Submission: Cashmere, Colombo, Dyers Pass safety improvements

Governors Bay Community Association Submission on the Proposed Cashmere, Colombo, Dyers Pass Safety Improvements

**Proposed Cashmere, Colombo, Dyers Pass Safety Improvements
Submission from John Bannock**

Cashmere, Colombo, Dyers Pass Safety Improvements

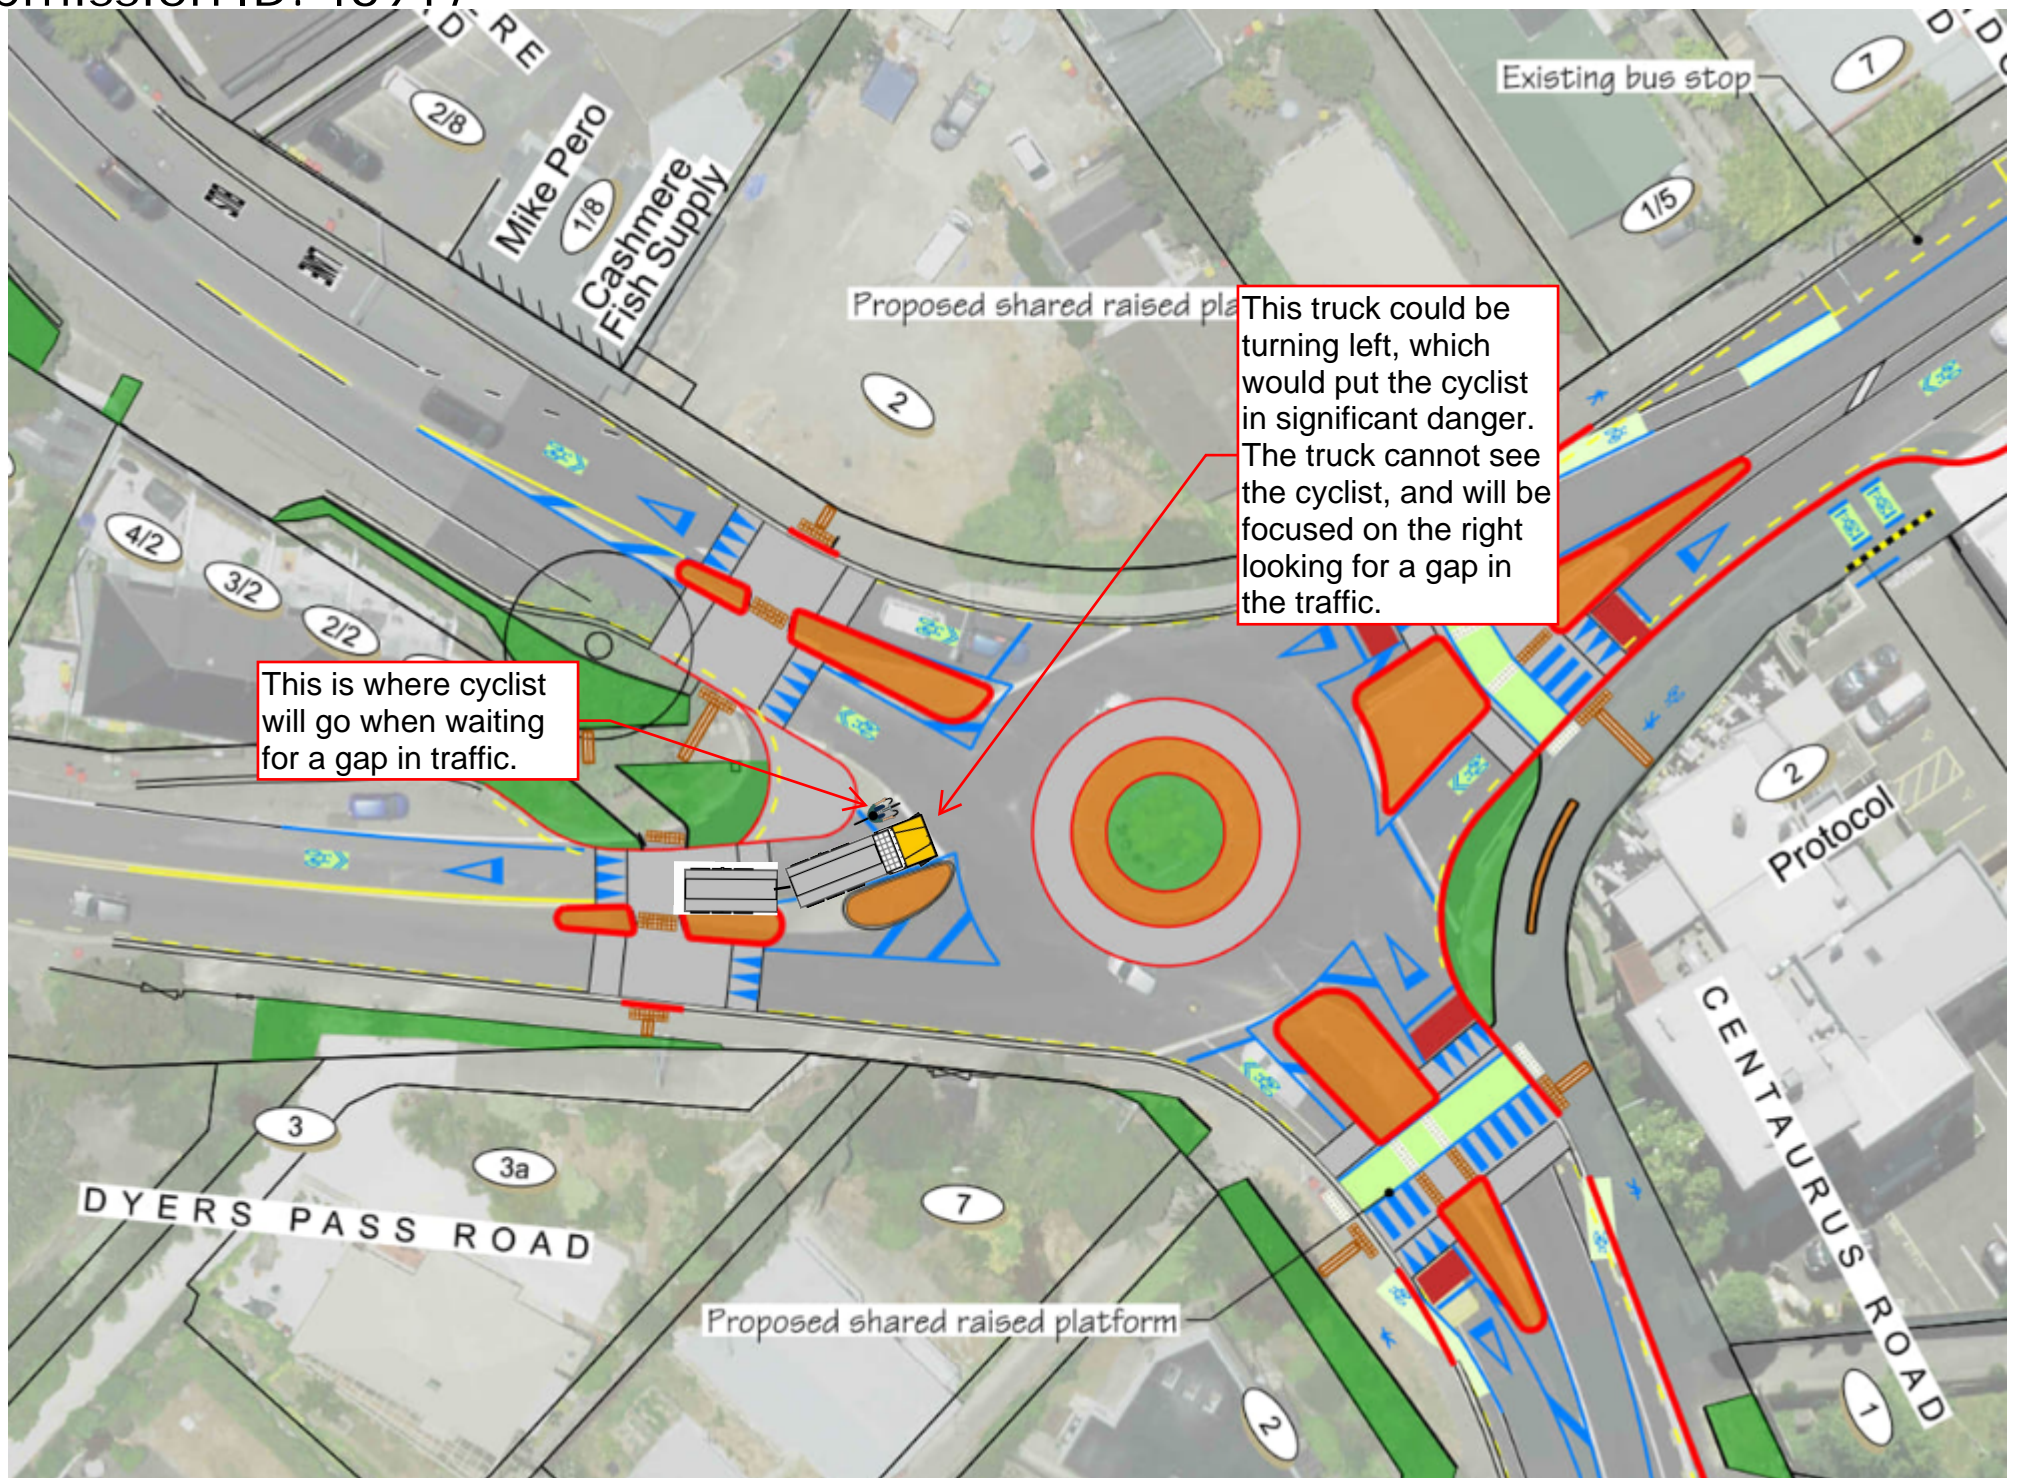
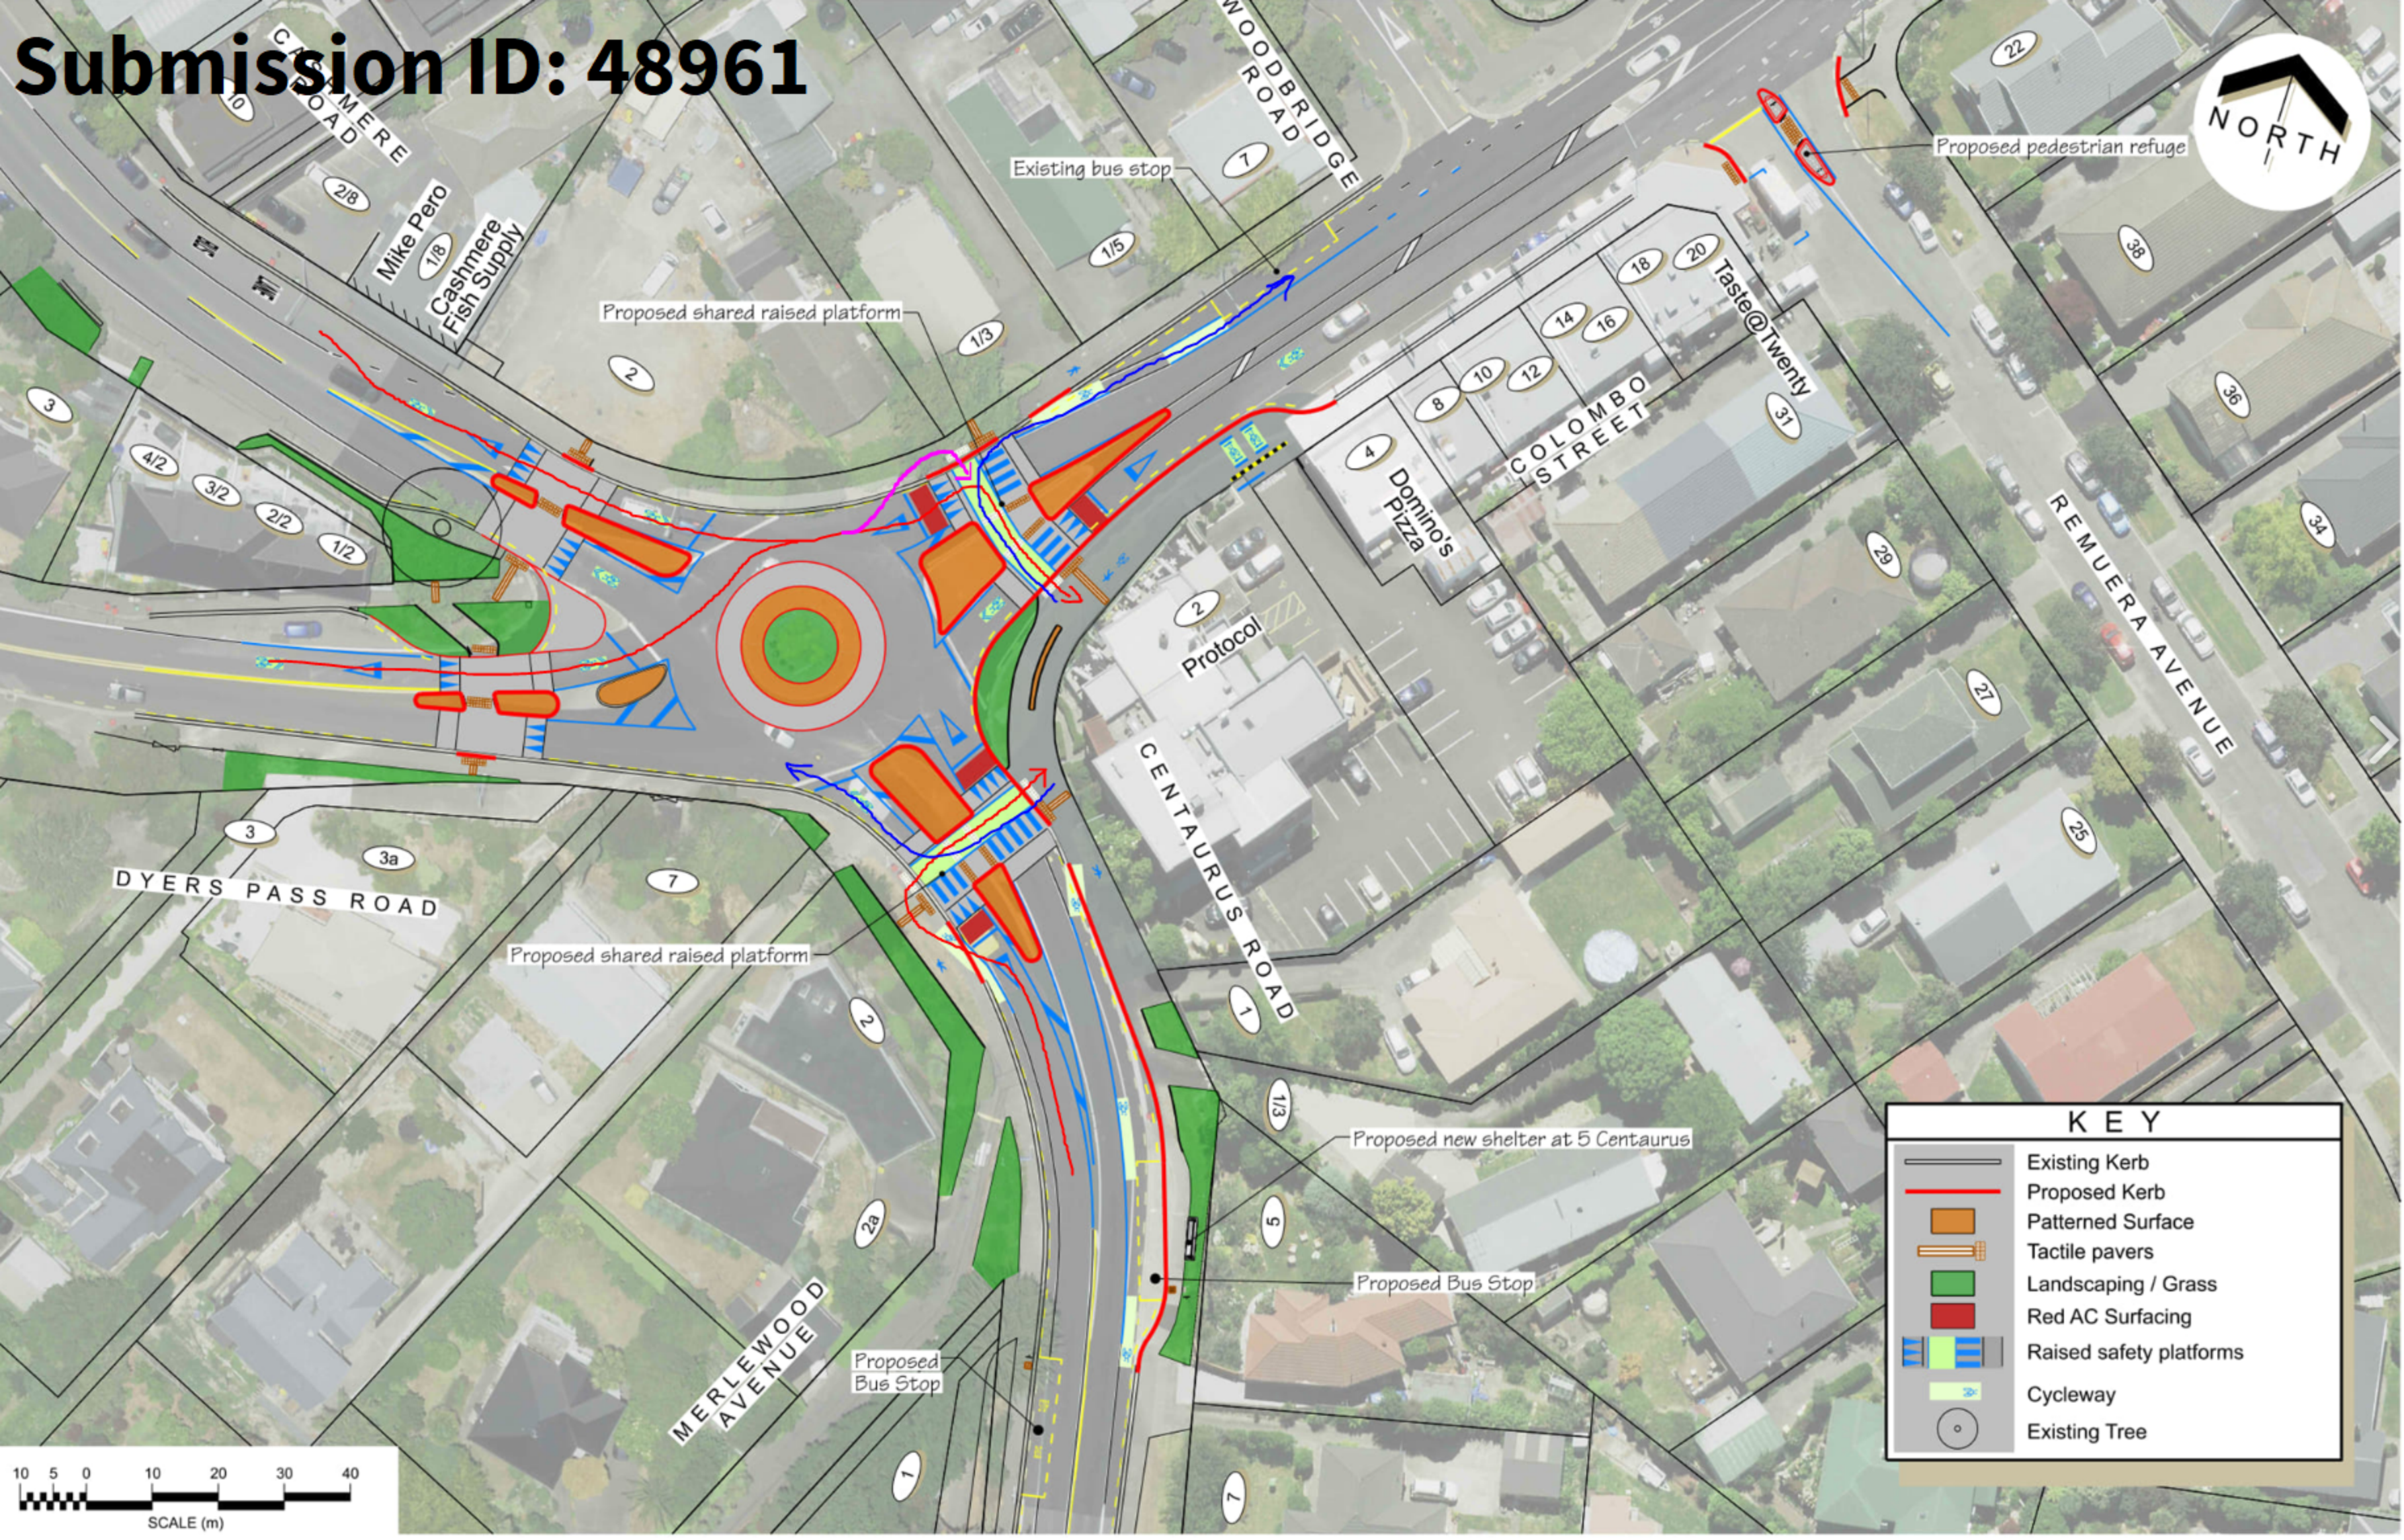
This truck will move the left lane prior to the roundabout. They can check for cyclists when changing as they do not need to be watching for a gap in traffic until after they cross the cycling lane.

This is where cyclist will go when waiting for a gap in traffic. All traffic to his right is going straight or right, so will not cut him off or crash with him.

Figure 1: Tail back - 6 December 2022 4:55pm

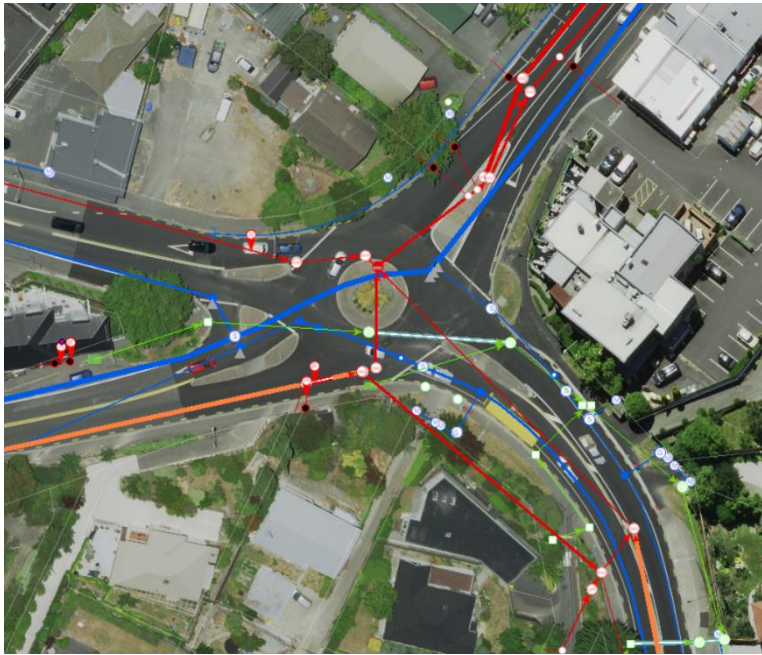
26. The traffic lights for the pedestrian crossing to Thorrington School currently causes tail backs that block the existing roundabout at the times of school dropoff/pick ups
27. Any traffic flow data collected in the past 3 years is likely to significantly underrepresent the real commuter traffic from the harbour area that would be expected to occur without the lengthy disruption of the road works on Dyers Pass Road
28. The purpose of roundabouts is to provide a way of ensuring a traffic flow in that cars enter and leave in a steady manner. The proposal will not achieve this with the volume of traffic not changing, the access to the intersection being limited and the requirement for traffic to stop on exit to allow pedestrians to cross.

29. I consider that the base data relating to traffic volumes used for the proposal (assuming there was some), will under represent the traffic volumes once the works on Dyers Pass Road will be completed (currently being carried out in excess of 3 years). The foundation of the design is therefore flawed.

Figure 2: Sketch from CCC indicating flat topography

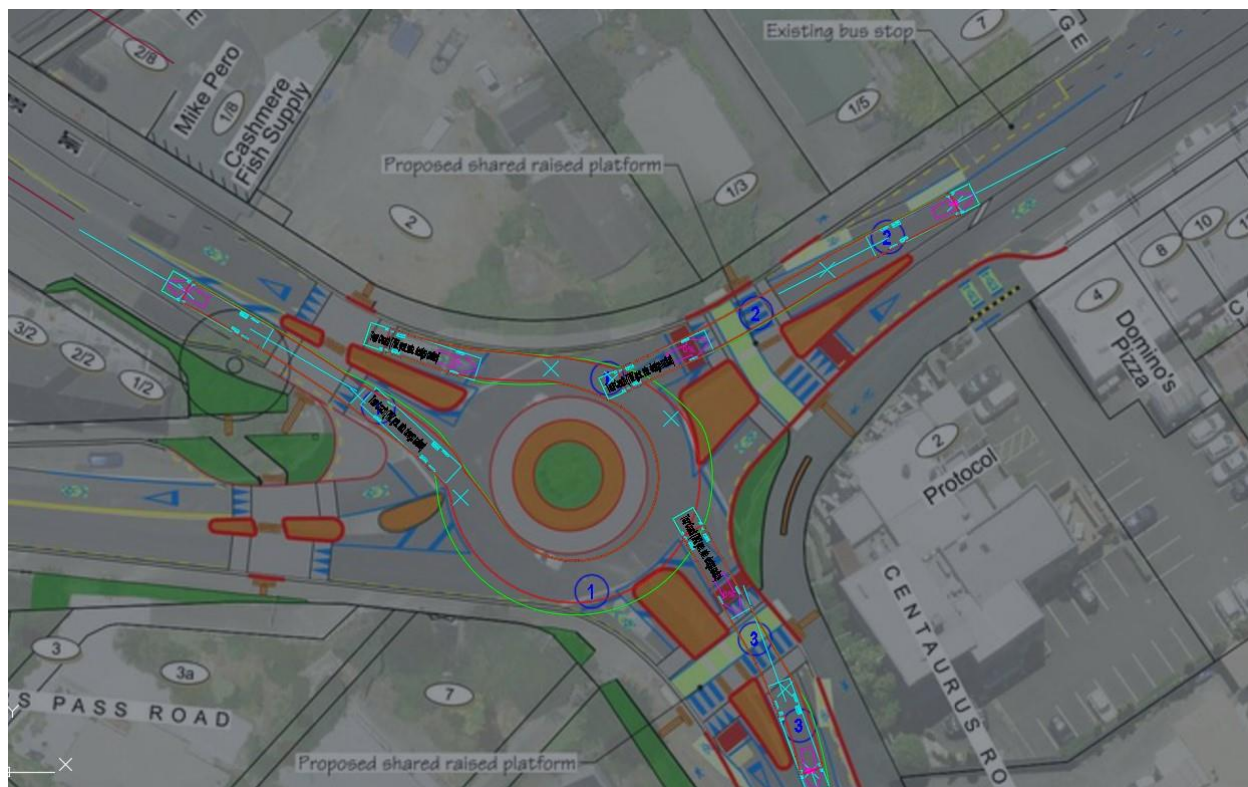
43. The diagrams provided by the Council appear to neglect the impact of road elevation on vehicle movements. This is a fundamental omission.
44. The presented proposal appears to have been prepared considering the plan view only. Due to the grade of Dyers Pass Road, this will have a significant impact on the design of the intersection.
45. With reference to the Dyers Pass Road, Centaurus Road intersection, the vertical alignment of Dyers Pass Road coupled with the acute angle of the intersection, suggests that an alternative route will not be easily trafficable by vehicles.
